YANKEE ATOMIC ELECTRIC COMPANY

Subject: Response to the NRC Questions on RELAP5YA

RESPONSE TO 80 QUESTIONS
ON RELAP5YA

July 1, 1985

Figure I.29-1 Comparison of Calculated (with and without Evap/Cond.) and Measured Accumulator Pressures for Maine Yankee Test

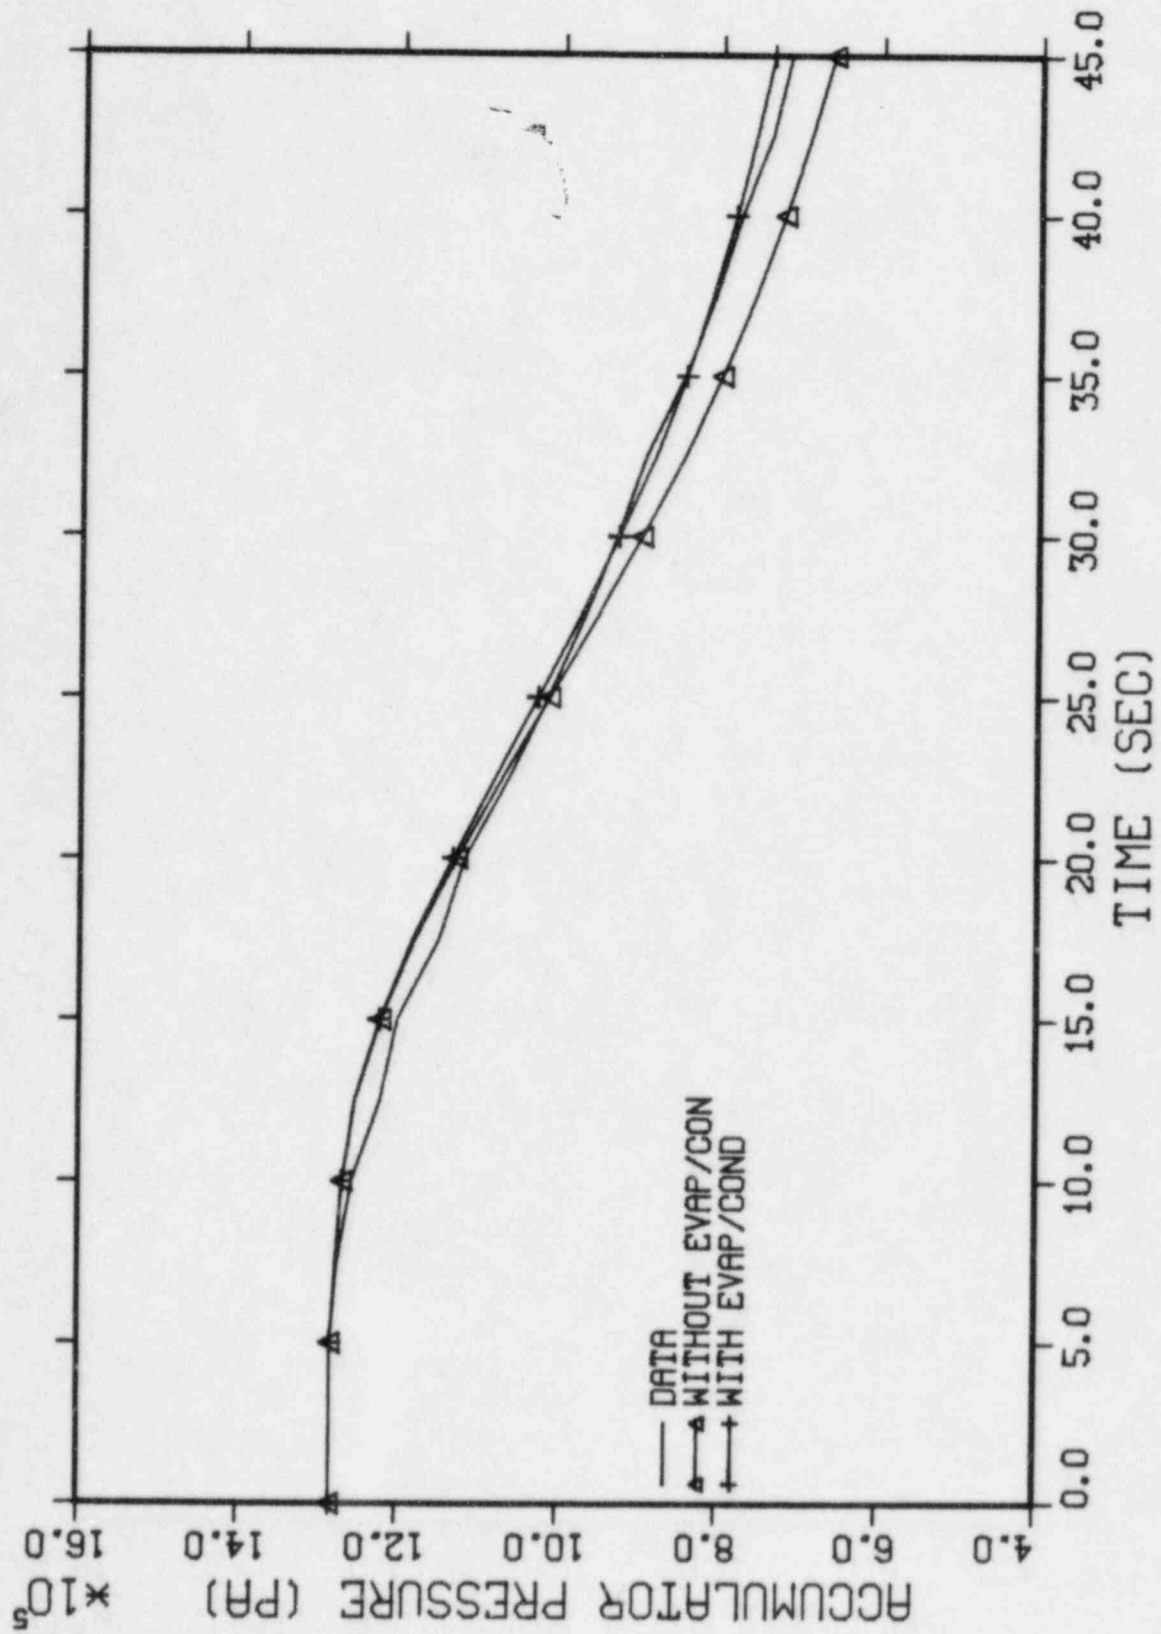
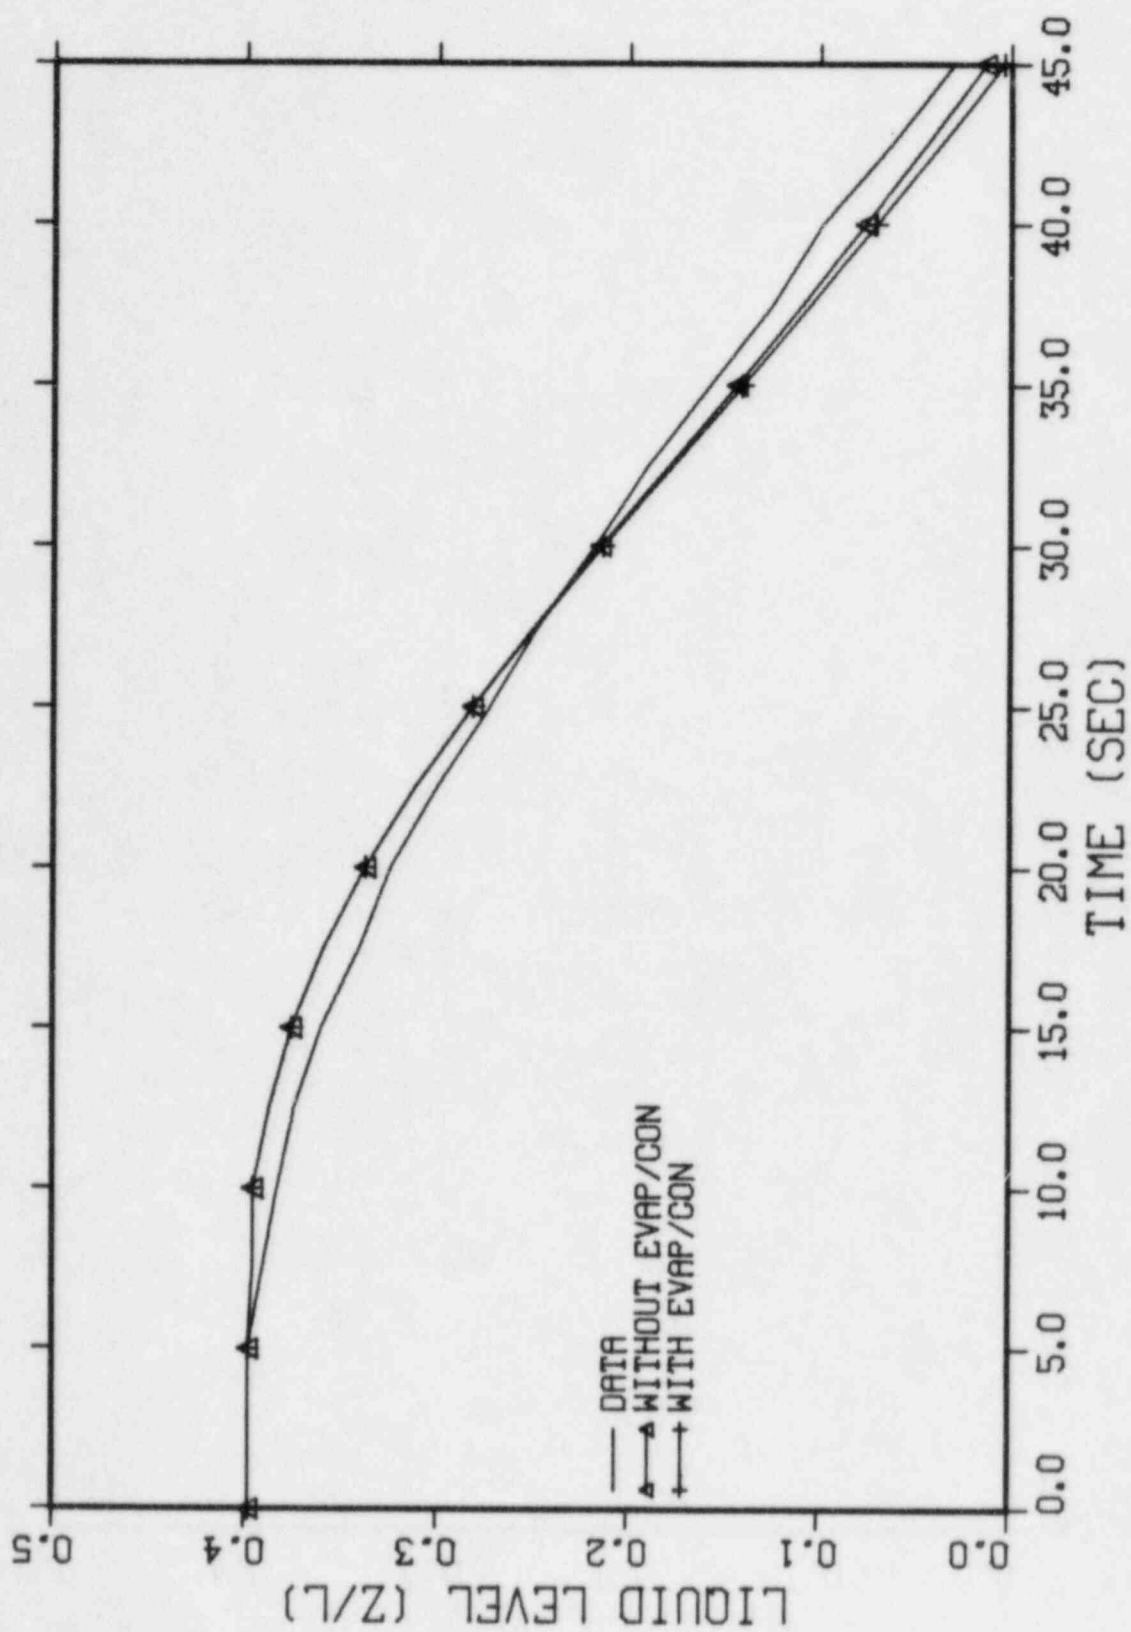
Clarify which curve is which and why the difference in pressures is increasing after 32 s even though the liquid levels are virtually identical.

As described in A.I.23, the accumulator model described in Chapter 3 of Reference I.23-1 has been replaced by the RELAP5/MOD1 Cycle 18 model. The Maine Yankee accumulator test has been recalculated with the revised model. Figures I.29-1 and I.29-2 compare calculated and measured accumulator pressure and liquid level, respectively. The accumulator pressure and liquid level are well predicted.

Figure IV.2-1 Proposed Maine Yankee Nodalization
SBLOCA EM Calculations

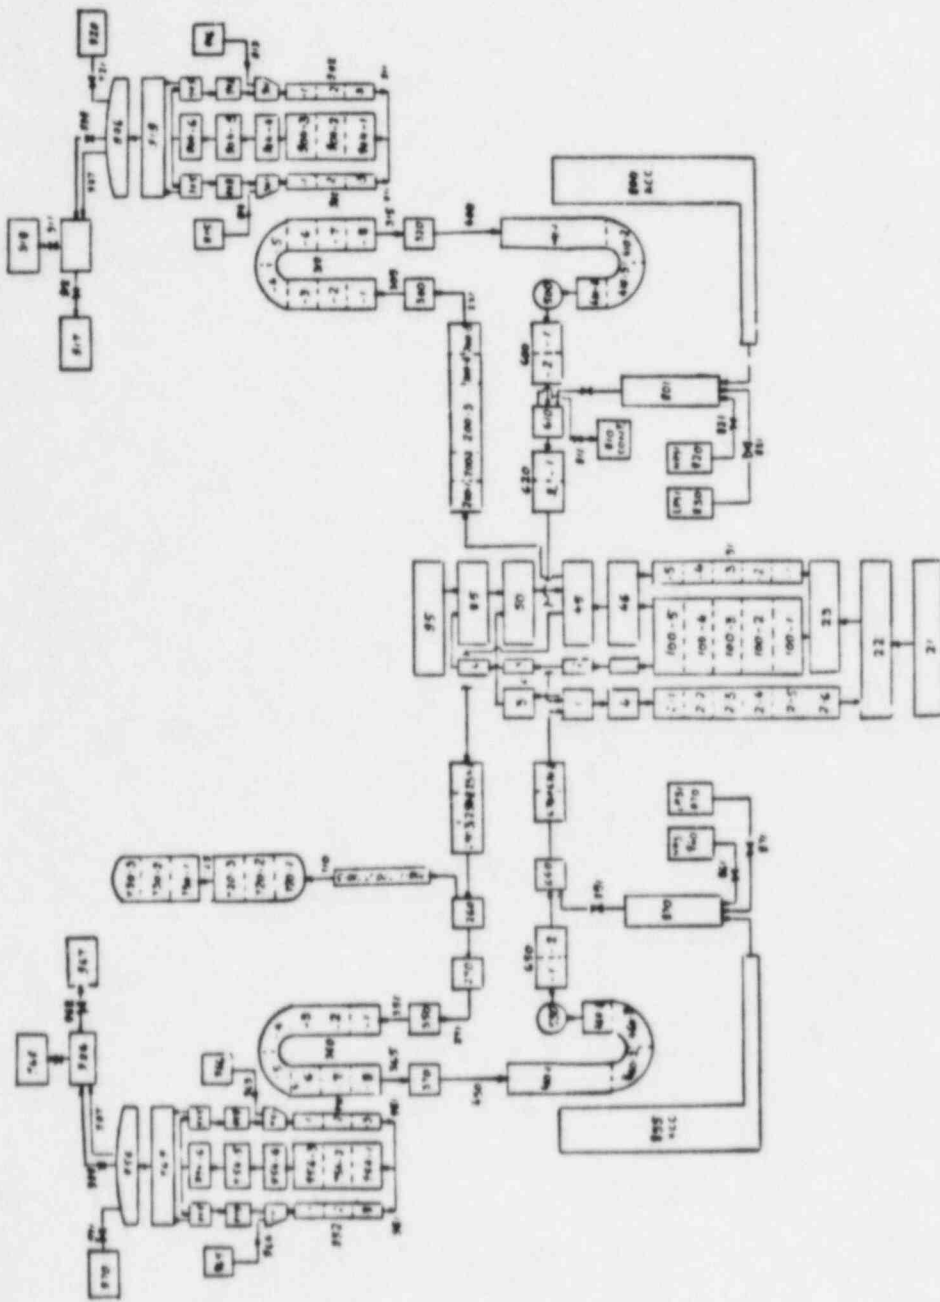
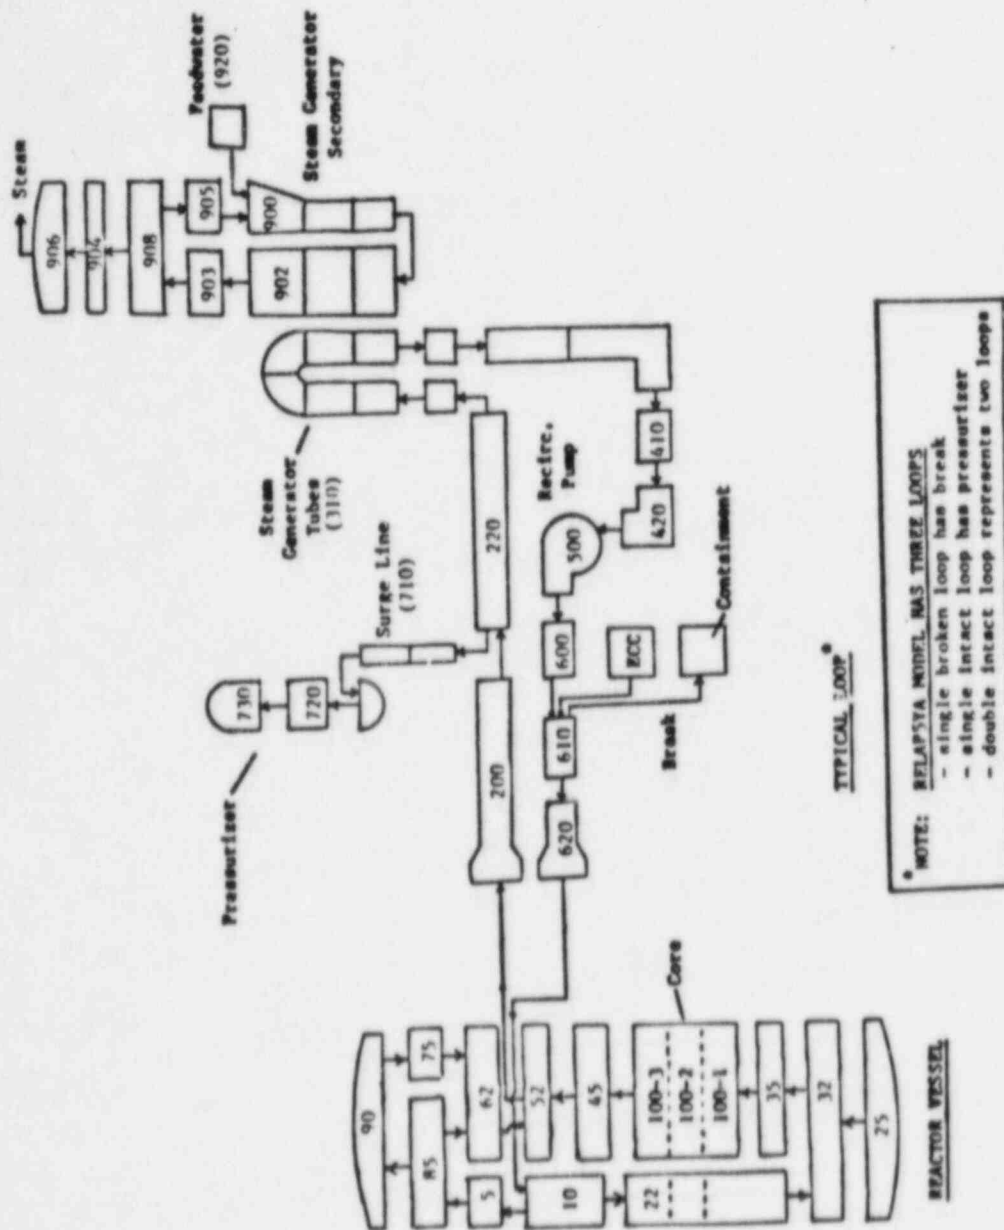
Clarify what steam generator nodding will be used for SBLOCA calculations.

Clarify what noding is needed to model steam generators for low flow and reflux cooling conditions in SBLOCA.

Figures IV.2-1 and IV.2-2 represent the nodalization used in the Pump Trip Studies for the Maine Yankee plant and Yankee plant at Rowe, respectively. Similar nodding schemes will be employed for the small break calculations.

Figures IV.2-1 and IV.2-2 provide representative noding schemes which will be used for all the phases of a SBLOCA accident, including low flow and reflux cooling conditions.
